Work Order ID 61303

Item Name: Basket Hoop

DESIGN #	DRAWN BY CP	DART AEROSPACE LTD HAWKESBURY, ONTARIO, CANADA	
CHECKED #	APPROVED #	DRAWING NO. D3166	REV. A SHEET 1 OF 1
DATE 02.07.10		TITLE BASKET HOOP	SCALE NTS
A	02.07.10	NEW ISSUE	
A1	04.04.08	38+/-1 WAS 36.0

DRAWING NO. D3166	TITLE BASKET HOOP	REV A1	DART AEROSPACE LTD ENGINEERING ORDER		D.E.O. NO. D3166-A-2	SHEET NO. 1 OF 1	SCALE NTS
DRAWN AJS	CHECKED L	MFG. APPR. M	APPROVED M		DE APPR. M		
DATE 08.12.11	DATE 08.12.15	DATE 08/12/15	DATE 08/12/16		DATE 08.12.16

D3166-1 BASKET HOOP

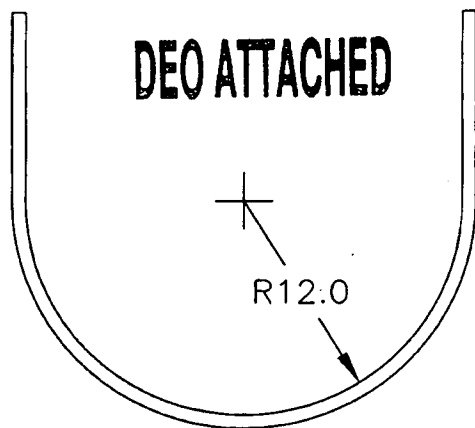
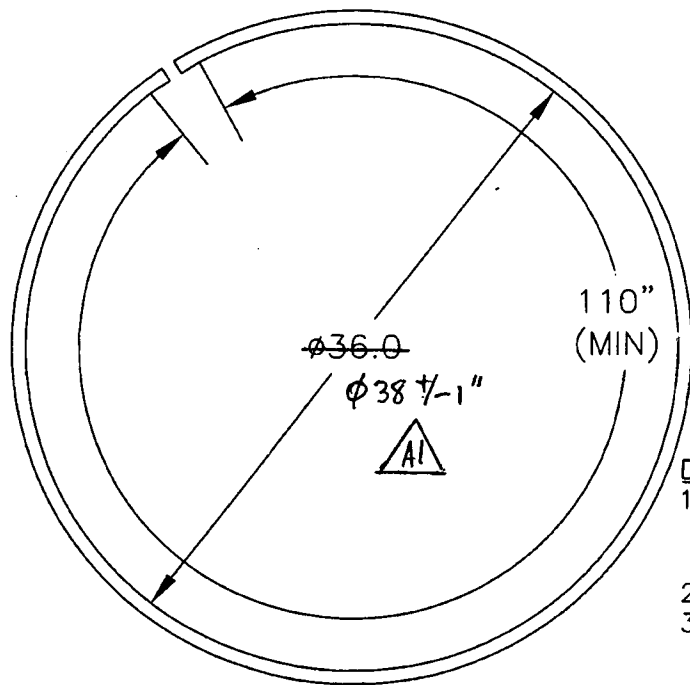
1) MODIFY MATERIAL NOTE FOR D3166-1 AS SHOWN:

WAS:

1) MATERIAL: AISI 304/316 SS SQUARE TUBING,
0.75" x 0.75" x 0.063 WALL, 60.00" LONG
(REF DART SPEC. M304TS0.750W.063)

2) MODIFY MATERIAL NOTE FOR D3166-3 AS SHOWN:

WAS:

1) MATERIAL: AISI 304/316 SS SQUARE TUBING,
0.75" x 0.75" x 0.063 WALL, 120.00" LONG
(REF DART SPEC. M304TS0.750W.063)

REASON: SEE PAR 08-005

IS:

1) MATERIAL: AISI 304/316 SS, 3/4 X 3/4 X 0.065 WALL SQUARE TUBING,
60.00" LONG
REF. DART SPEC M304TS0.750W.065

IS:

1) MATERIAL: AISI 304/316 SS, 3/4 X 3/4 X 0.065 WALL SQUARE TUBING,
120.00" LONG
REF. DART SPEC M304TS0.750W.065
